McCULLOCH SERVICE BULLETIN

NO. 1693

MODEL Pro Mac 600 Series DATE October 1, 1979

SUBJECT Air Filter, P/N 95215

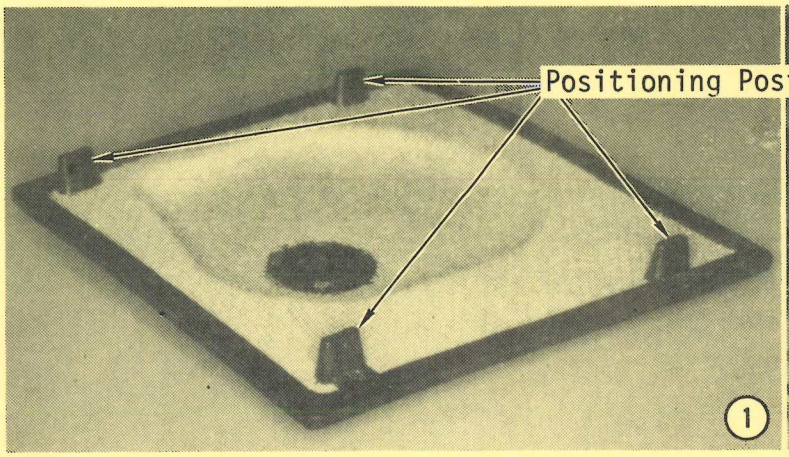
In an effort to improve the alignment characteristics of the 610/650 air filter, the air filter has been modified to incorporated four positive positioning posts (Figure 1).

The improved Air Filter, P/N 95213, is installed on all current production 610/650 chain saws, and is available as a service part.

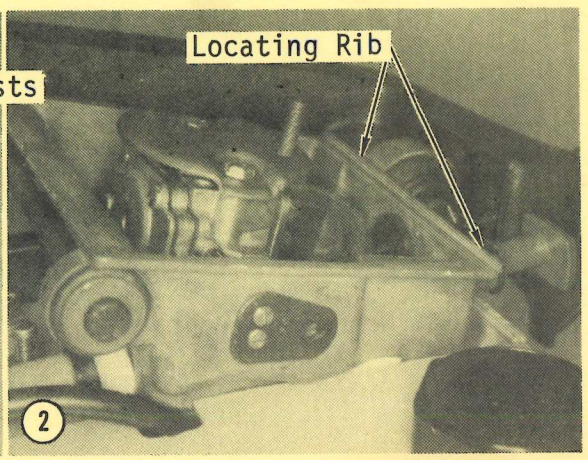
Because the new filter has the positive positioning posts, the locating rib (Figure 2) incorporated in early production Air Box, P/N 91920, has been removed. The modified (new) air box is available as a Kit, P/N 95215, which includes Air Filter, P/N 95213. The new Air Box, P/N 95215, replaces Air Box, P/N 91920.

All skin packed Air Filters, P/N 92055, shipped as of 6/25/79, will contain Air Filter, P/N 91920 (Figure 2).
